# City of Mississauga Department Comments

Date Finalized: 2022-07-20 File(s): A321.22

Property Address: 243 Lakeshore Rd E

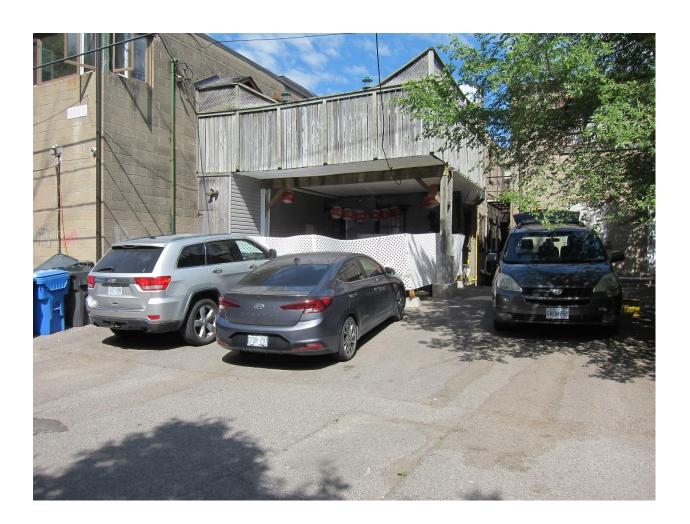
Attached for Committees information are photos of the front of the building and also the existing rear parking area.
